Kentucky Transportation Cabinet Value Engineering Study Mountain Parkway Corridor – Construction Sequence 1

Final Value Engineering Study Report

Study Dates: May 12-16, 2014

November 14, 2014

VALUE ENGINEERING PROPOSAL SS-04

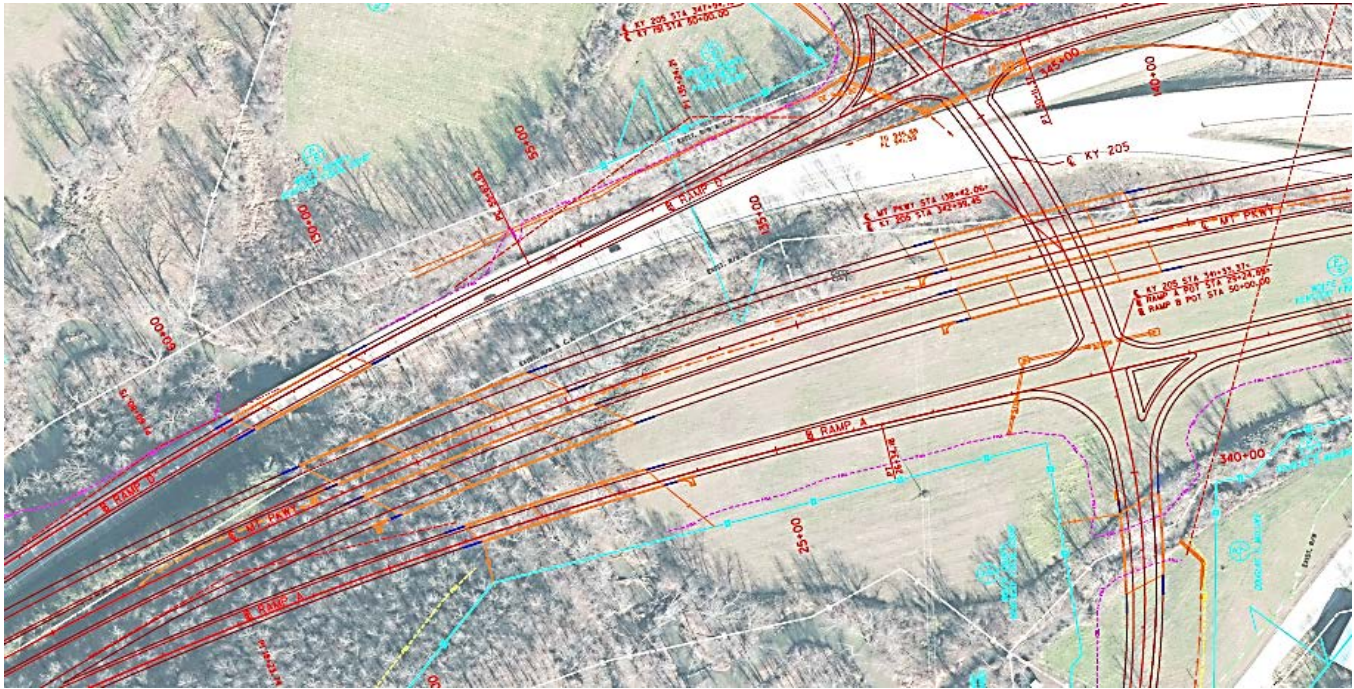
Replace all the bridges over Red River with precast arch bridges.

VALUE ENGINEERING PROPOSAL SS-05

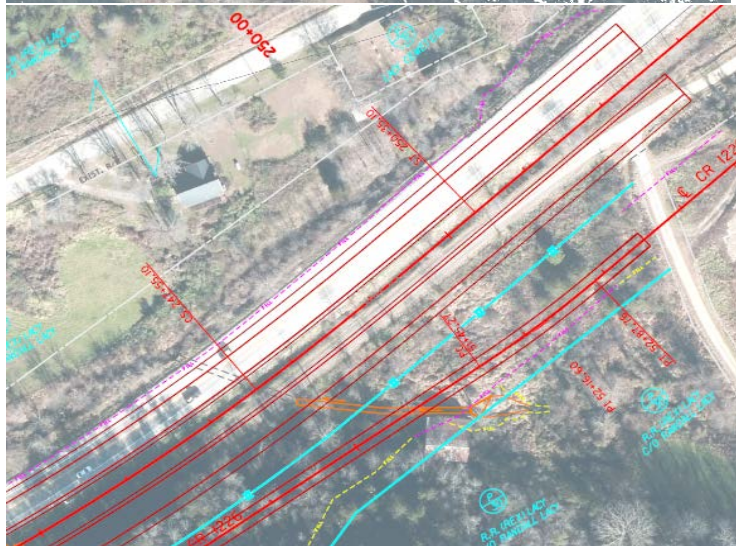
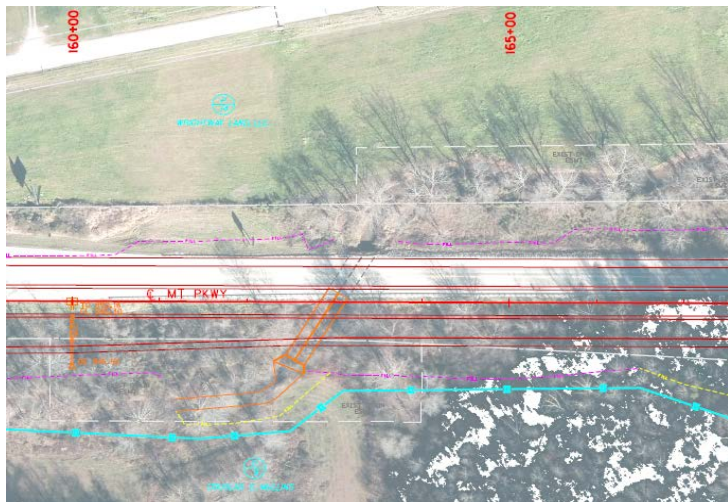
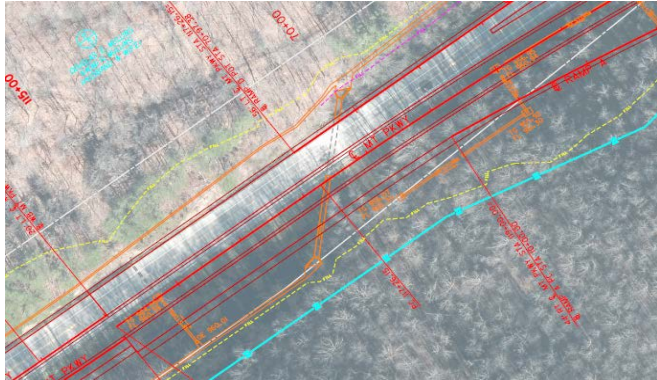
TITLE: Use arch bridge in-lieu of box culvert - three opportunities			
FUNCTION: Span Space			
BASELINE ASSUMPTION:			
Three box culvert (Double 12 LF X 7 LF Sta. 163+00, 6 LF X 5 LF Sta. 117+40, and 6 LF X 5 LF Sta. 248+00) extensions are proposed.			
PROPOSED ALTERNATIVE:			
Use arch-culverts in lieu of box culverts. Replace the Double 12 LF X 7 LF with a 24 LF X 8 LF arch-culvert. Replace the 6 LF X 5 LF with a 12 LF X 4 LF arch culvert.			
BENEFITS		RISKS/CHALLENGES	
<ul style="list-style-type: none"> Reduces cost 		<ul style="list-style-type: none"> Connecting to the existing box culverts 	
<ul style="list-style-type: none"> Achieves better hydraulic capacities versus double box culvert 		<ul style="list-style-type: none"> 	
<ul style="list-style-type: none"> Reduces the chances of silting on the double box culvert 		<ul style="list-style-type: none"> 	
<ul style="list-style-type: none"> Reduces the in-lieu fees associated with culverts 		<ul style="list-style-type: none">

VALUE ENGINEERING PROPOSAL CR-21

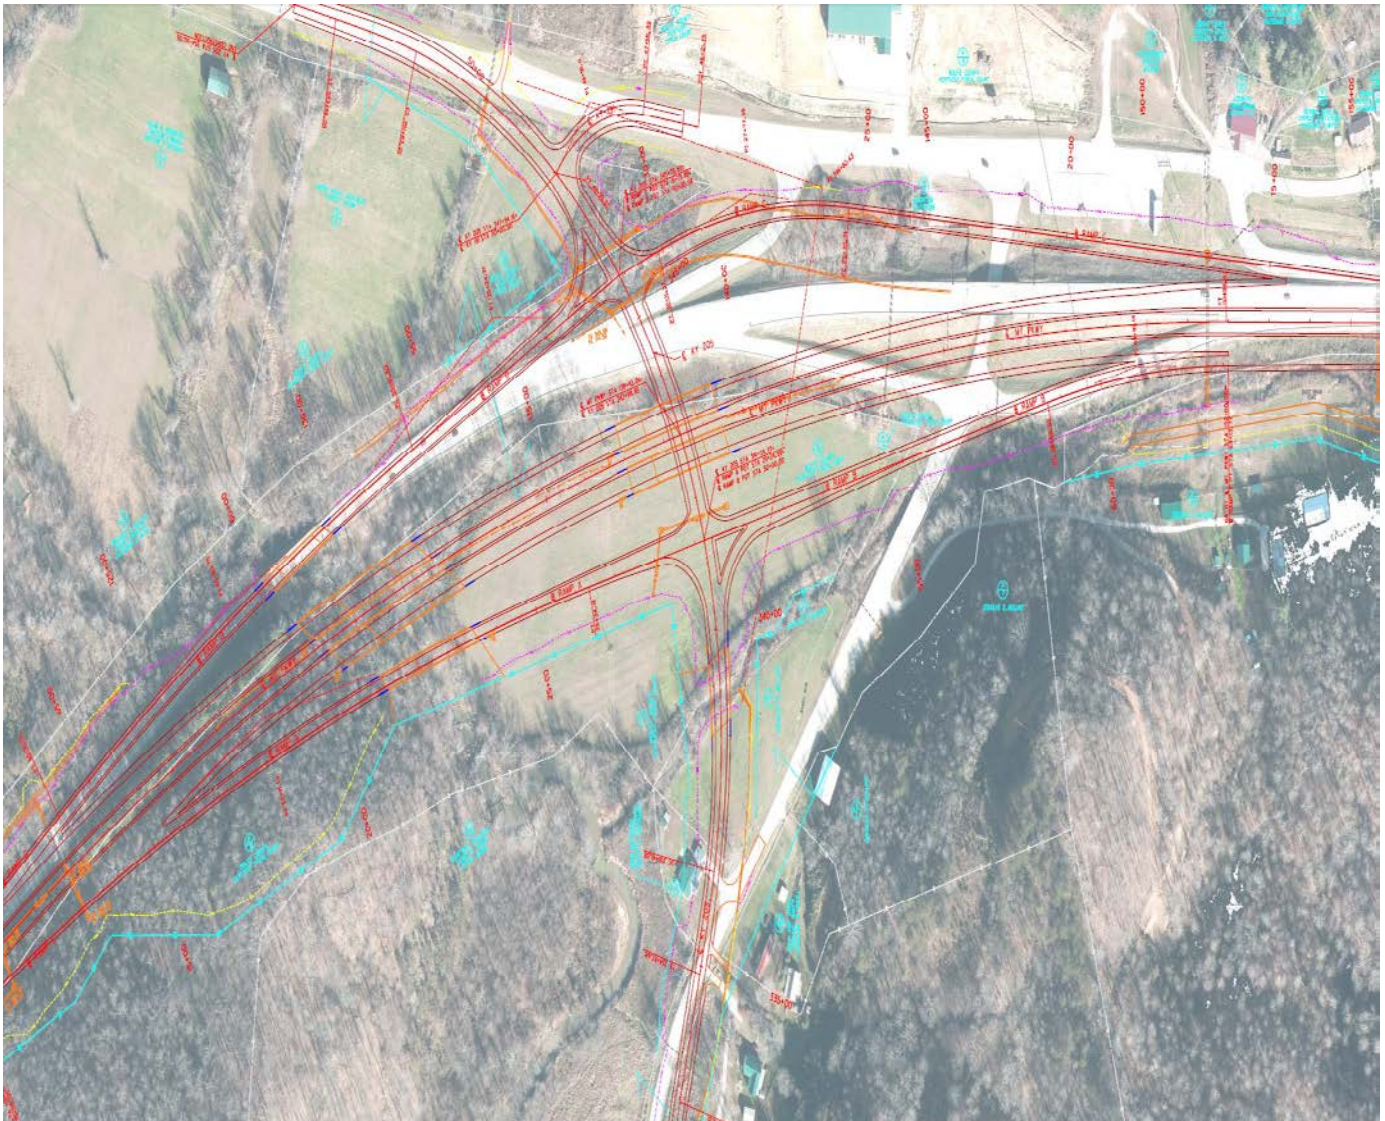
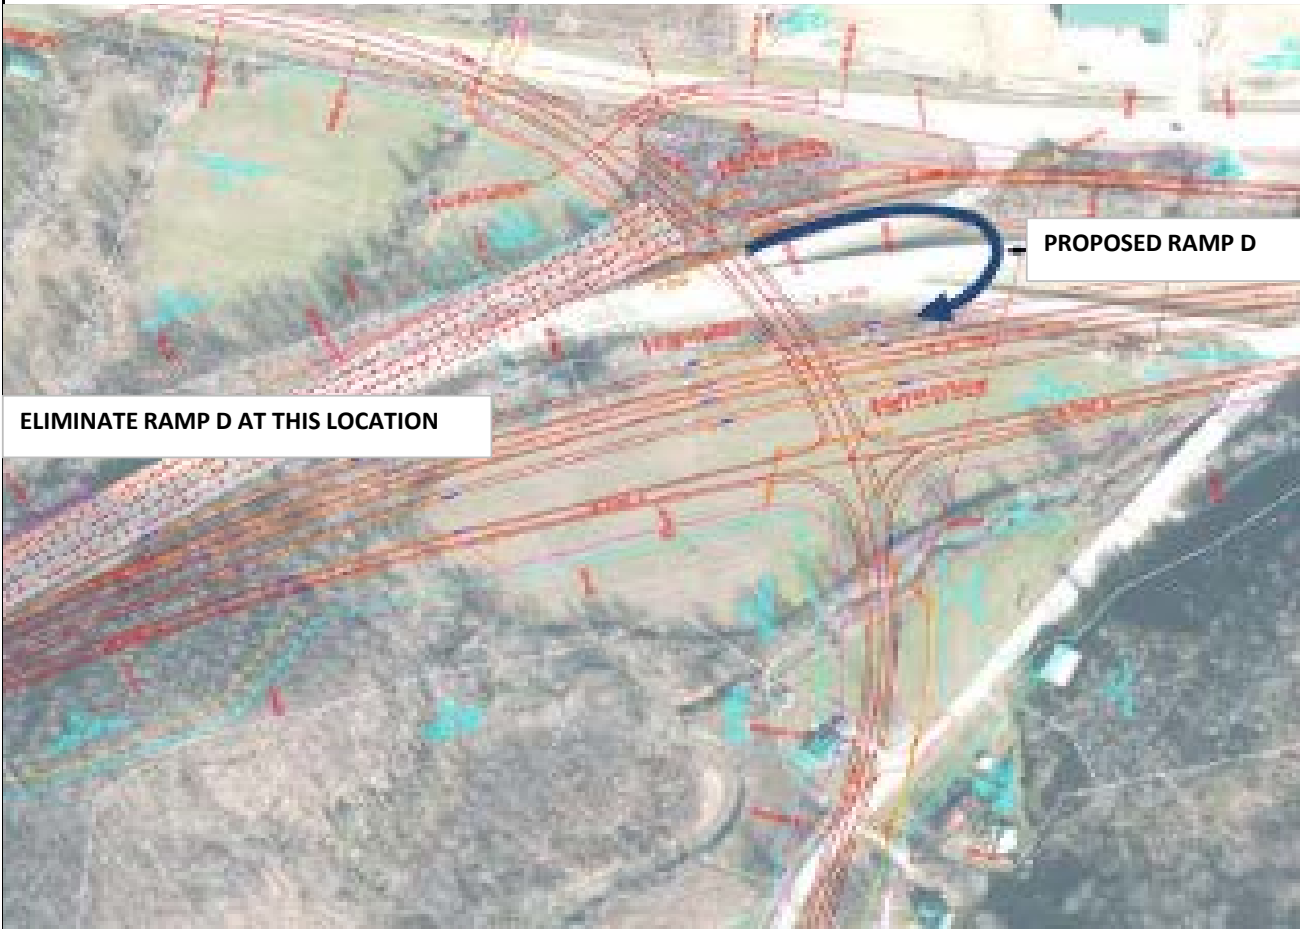
Replace Ramp D with a jug handle ramp.

TITLE: Use a jug handle interchange in lieu of a diamond interchange at KY 191

Proposed bridge widening adds an additional 16 LF in width to the 243 LF long bridge. Jug handle ramp length is 800 LF.

VALUE ENGINEERING PROPOSAL SS-06

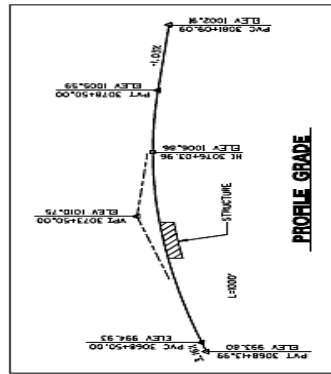
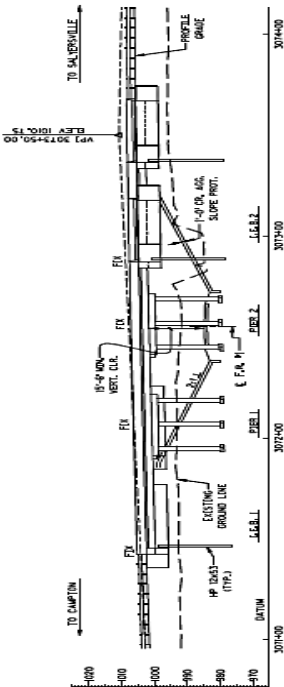
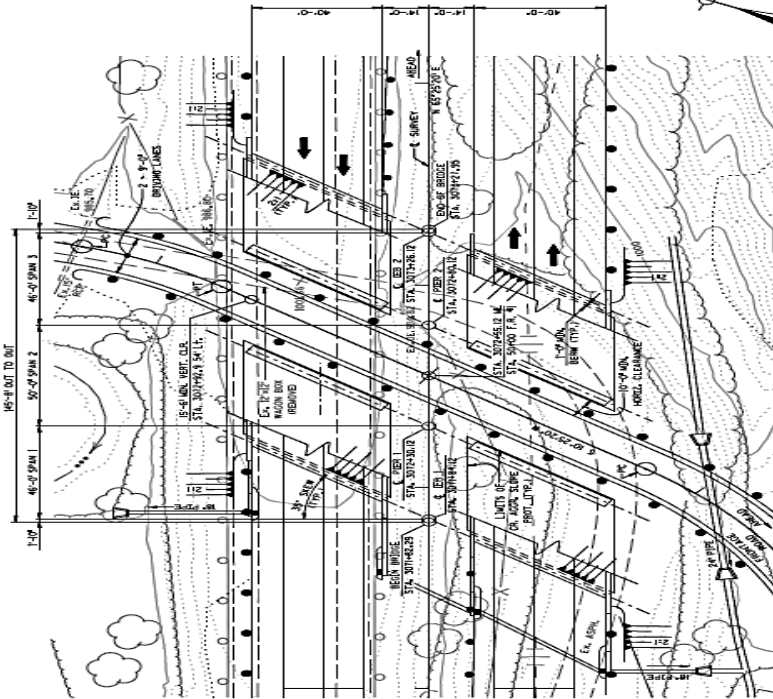
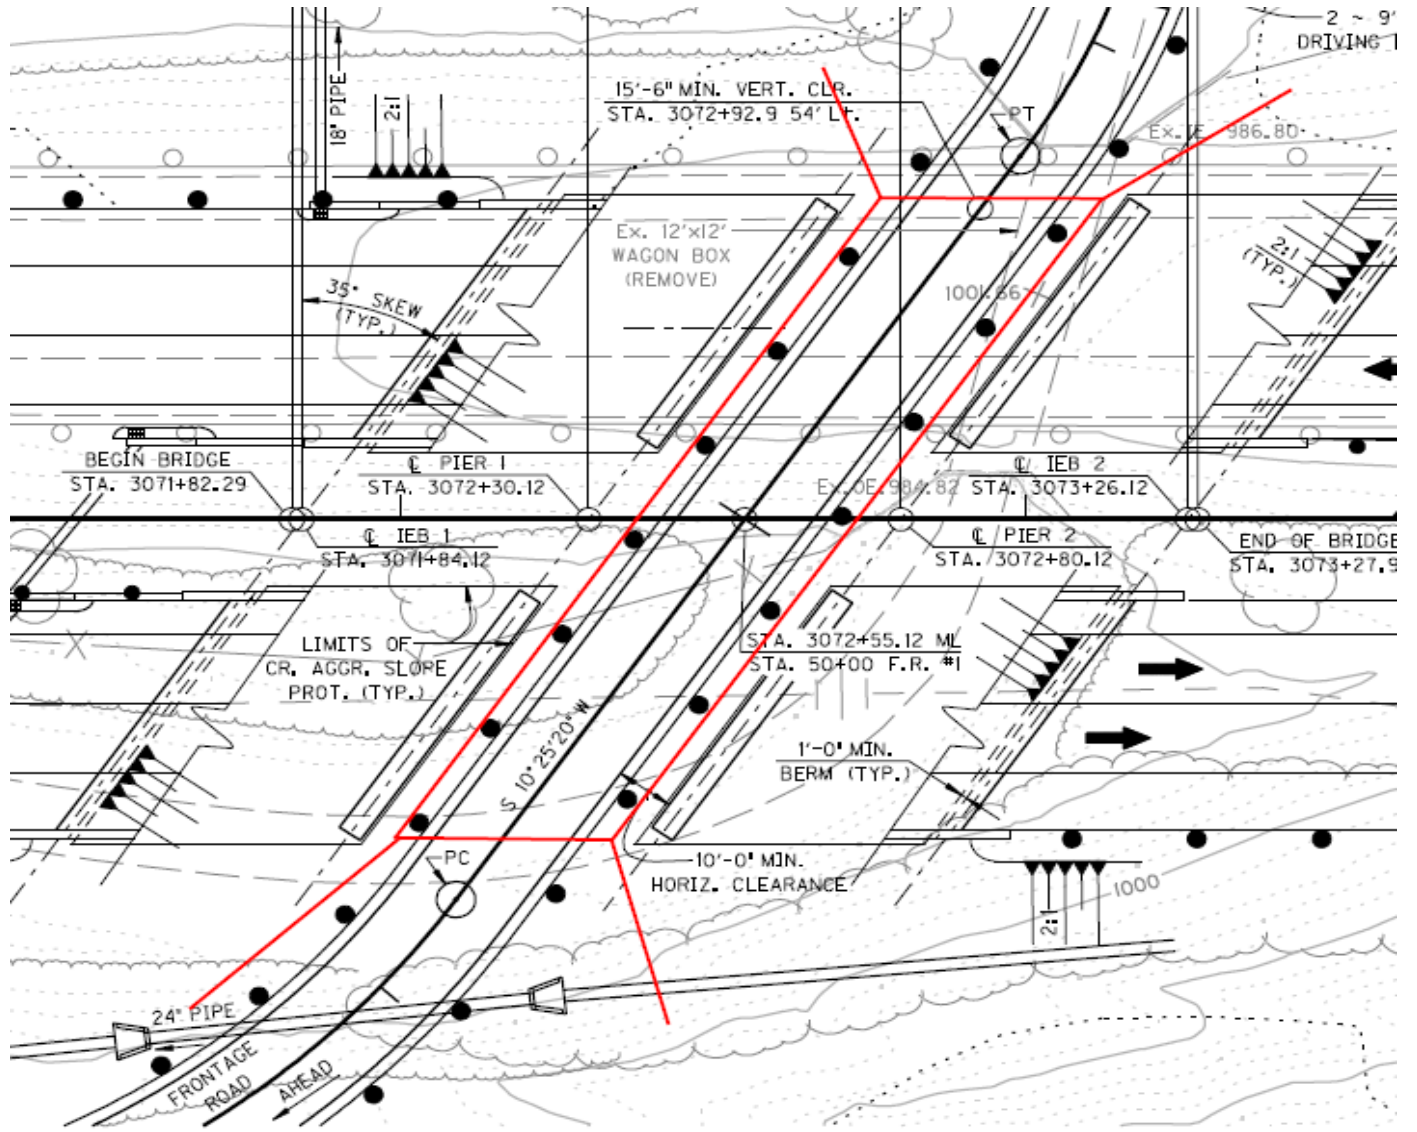
TITLE: Use single-span bridge at Sta. 3072+55 in lieu of three-span bridge
